**TESORO  
LOS ANGELES REFINERY  
INTEGRATION AND COMPLIANCE PROJECT  
FINAL  
ENVIRONMENTAL IMPACT REPORT**

**VOLUME VII: Appendix G (G1-81 Attachment 24 – Response G1-97.3)**

**SOUTH COAST AIR QUALITY MANAGEMENT DISTRICT**

Table 2: Predominant Crude Oil sulfur and API gravity range in DEIR figures 2-6 and 2-7

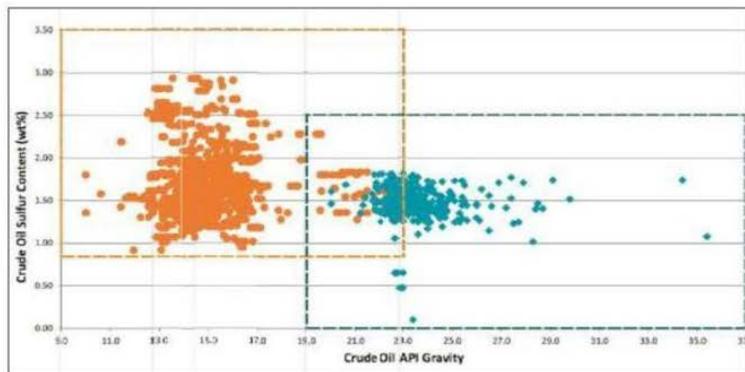
DEIR Figure 2-7 above shows for Carson	DEIR Figure 2-6 above shows for Wilmington
Crude Units 1&4 (lower cluster): Mainly ~0.8-1.4% sulfur, Crude Unit 2 (upper scatter): Mainly about 1.8-3% sulfur	Crude Unit (in right box cluster) Mainly about 1.3-1.7% sulfur
All three Carson Crude Units show API gravity mainly about 29-32° API	Mainly about 21-25° API
The DEIR describes <i>the whole range</i> for the refinery Sulfur & API range <i>capability</i> , including the tail ends outside the main clusters, and not the historical <i>baseline</i>	
API gravity range of 28-35° 0.6-3.5 weight % sulfur	19-37° API 0.0-2.5 weight % sulfur

Table 2 of the comment presents average crude oil property data based on the data provided in the DEIR (Figures 2-6 and 2-7). The point of Figures 2-6 and 2-7 of the DEIR is that the properties of the crude oil blend processed by the Refinery may change, but they will fall within the operating envelope, or ranges of crude oil properties, capable of being processed by the Refinery. Average crude oil properties do not represent the variety of crude oil blends that fit within the Refinery's operating envelope.

**Figure 81.59-1**  
**Alaska Crude Oil Production**  
**2002-2015**

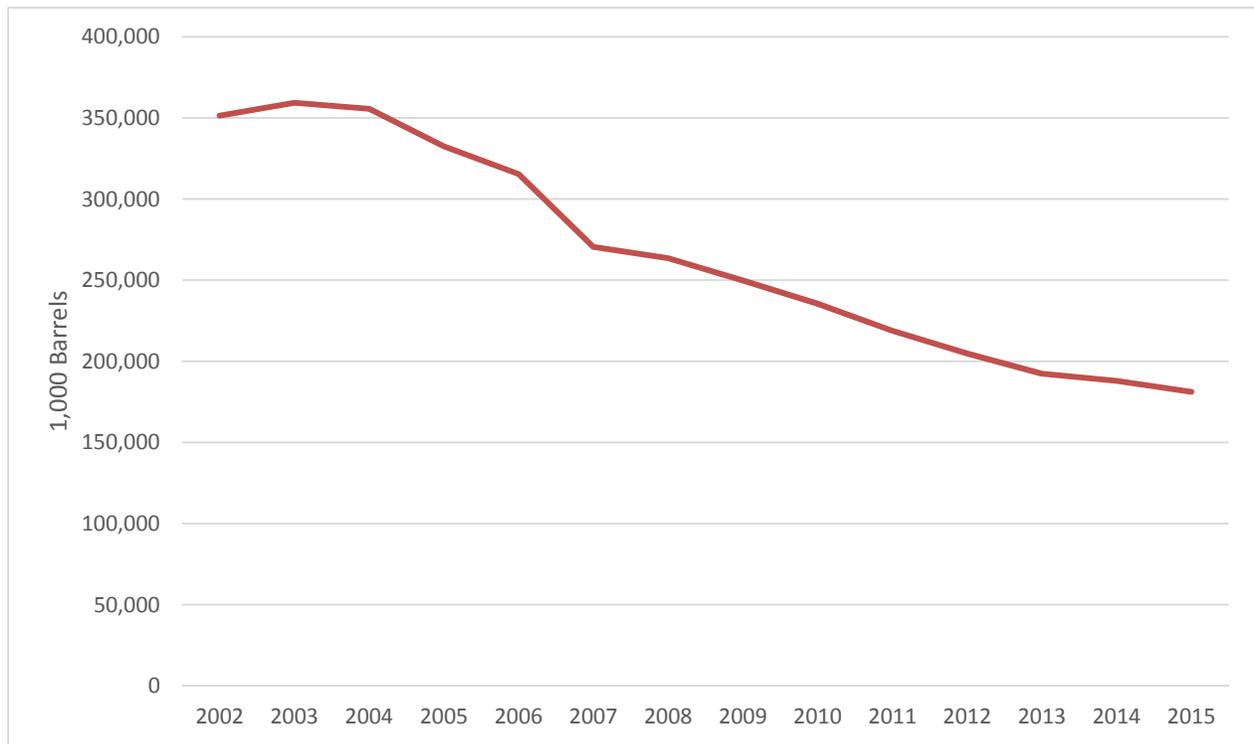
The comment quotes a Bloomberg article that is not cited, and therefore, the quotes cannot be verified. The comment claims based on the Bloomberg article, that production of crude oil from PADD 5, which includes Alaska and California, is declining. Figure 81.59-1 confirms that production of Alaska crude oil continues to decline. However, California crude oil production has leveled and remains steady in recent years. Response G1-78.178 provides a detailed summary of California crude oil production in response to previous comments on this issue, and demonstrates that California crude oil production has remained level in recent years.

As shown in Figure 81.59-1, Alaskan crude oil production has declined significantly in the last 15 years. The Refinery is already processing other light crude oils to replace the ANS crude oil previously processed. For example, as illustrated in Comment G1-81.36, the Refinery processes a substantial amount of light Basrah crude oil. While a limited amount of Bakken crude oil can be processed by the Refinery, many other light crude oils can also be included in the crude oil blend processed by the Refinery. The proposed project is not designed to facilitate a change in the crude oil blend processed by the Refinery, except to the extent that the DCU H-100 heater permit revisions may allow the processing of a slightly heavier crude oil blend. The proposed project is not dependent upon processing any particular type of crude oil.

**Figure 81.69-1**  
**Historical Number of PRVs Added to the Flare Gas Recovery System and Historical Flaring Emissions for the Tesoro Los Angeles Refinery (2007-2015)**

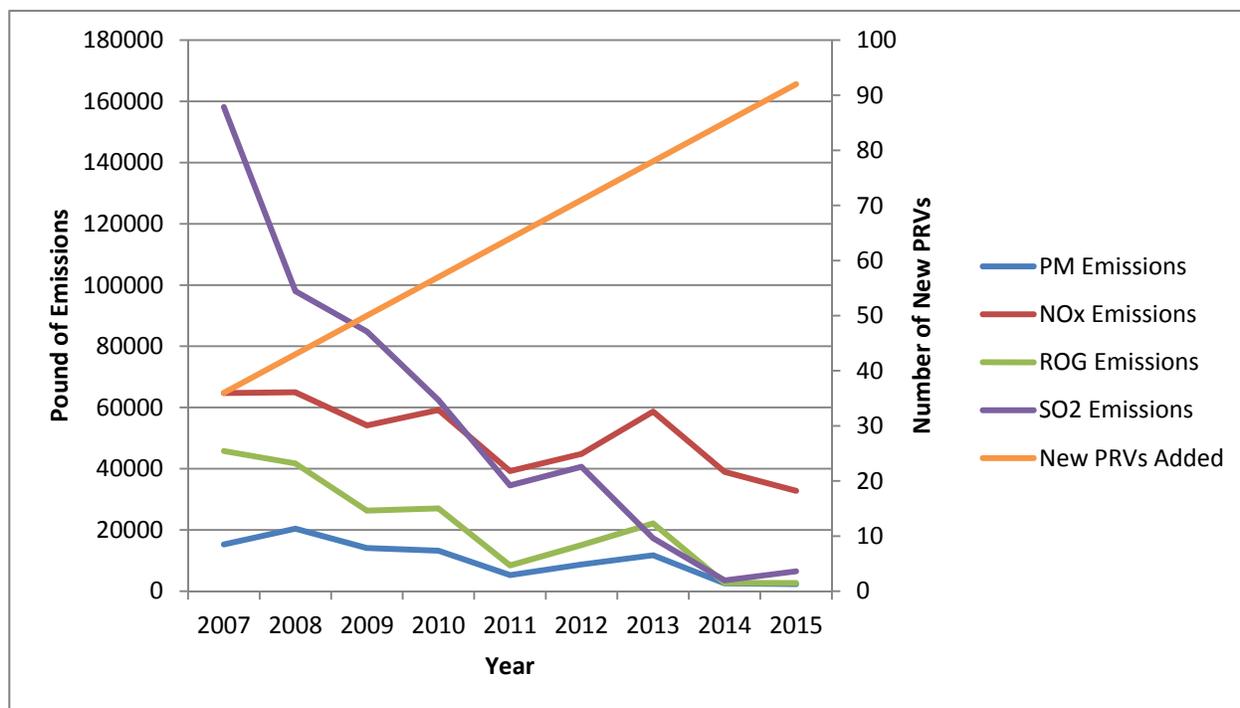
At petroleum refineries, flares have historically been used to dispose of combustible gases resulting from emergency relief, overpressure, process upsets, startups, shutdowns and other operational and safety reasons to prevent direct release of toxic and /or odorous substances to the atmosphere. In recent years, U.S. Occupational Safety and Health Administration (OSHA) and U.S. EPA have become more concerned with refinery operation, resulting in tighter regulations on safety and emissions control and enforcement actions such as Consent Decrees, as shown before. **Furthermore, smoke, noise, glare and odors sometimes associated with refinery operations may, and at times have impacted the surrounding communities**, leading to an increase in the involvement of community and environmental groups in the regulatory process of controlling refinery flares. (emphasis added)

The comment provides information on existing baseline flaring emissions. No specific comments on the DEIR are made. Master Response 15 provides historical hours and flowrate from flaring, which show historical decreases. Figure A of the comment shows the variability in flaring events. However, as described in Response G1-78.207 and shown in Figure 81.69-1, overall flaring has decreased dramatically since revisions to SCAQMD Rule 1118 were implemented.

While not explained in the body of the comment, the title to the comment mentions the addition of pressure relief valve (PRV, also called pressure relief device (PRD) or pressure safety valve (PSV)) connections to the flare. As described in Response G1-78.207, increasing connections to the flare gas recovery system does not equate to an increase in flaring emissions. Figure 81.69-1 shows that even with increased pressure relief connections added to the flare gas recovery system, flaring emissions have been reduced.

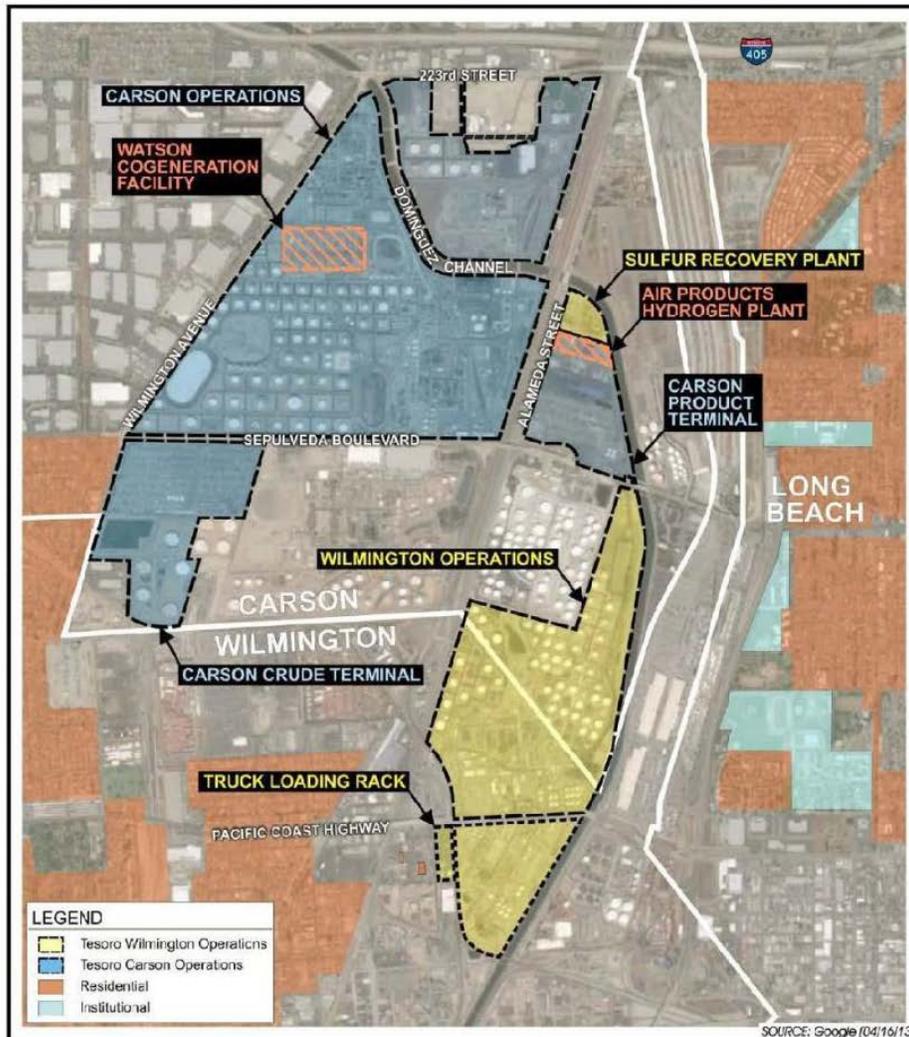
The DEIR did provide the following map, showing residences in close proximity, surrounding the two refineries, although a larger map would show additional impacted residences:

The comment reproduces Figure 2-2 from the DEIR and states that a larger map would show additional impacted residences. Figure 2-2 along with Figure 2-1 comply with CEQA Guidelines § 15124(a), which states, “The precise location and boundaries of the proposed project shall be shown on a detailed map, preferably topographic. The location of the project shall also appear on a regional map.” For maps that show areas outside the boundaries of the
